### Report for Bowie #1 inspection

INSP-REPORTC\_C1981038\_RDZ\_07182024.pdf

Permit Number: C-1981-038 Mine Name: Bowie No. 1 Mine Operator: Bowie Resources, LLC Operator Address: Mr. Basil R Bear	County: Delta Operation Type: Underground Permit Status: Active Ownership: Private			
P.O. Box 1488	Operator Representative Present:			
Paonia, CO 81428	None			
Operator Representative Signature: (Field Issuance Only)

Inspection Start Date: July 16, 2024 Inspection Start Time: 14:00 Inspection End Date: July 16, 2024 Inspection End Time: 15:30			Inspection Type: Coal Partial Inspection Inspection Reason: Normal I&E Program Weather: Raining		
Joint Inspection Agency:		Joint	Joint Inspection Contacts:		
None					
Post Inspection Agency:		Post Inspection Contacts:			
None					
Inspector(s):	Inspector's Signature: Signature		Signature Date:		
Robert Zuber, P.E.	Phot D. ZL				
				7/18/2024

Cheat grass at Coal Storage Area near Black Bridge Road

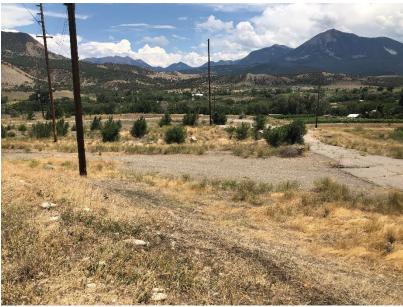
Large quantities of cheat grass were observed at the Coal Storage Area (near Black Bridge Road). This noxious weed should be treated.
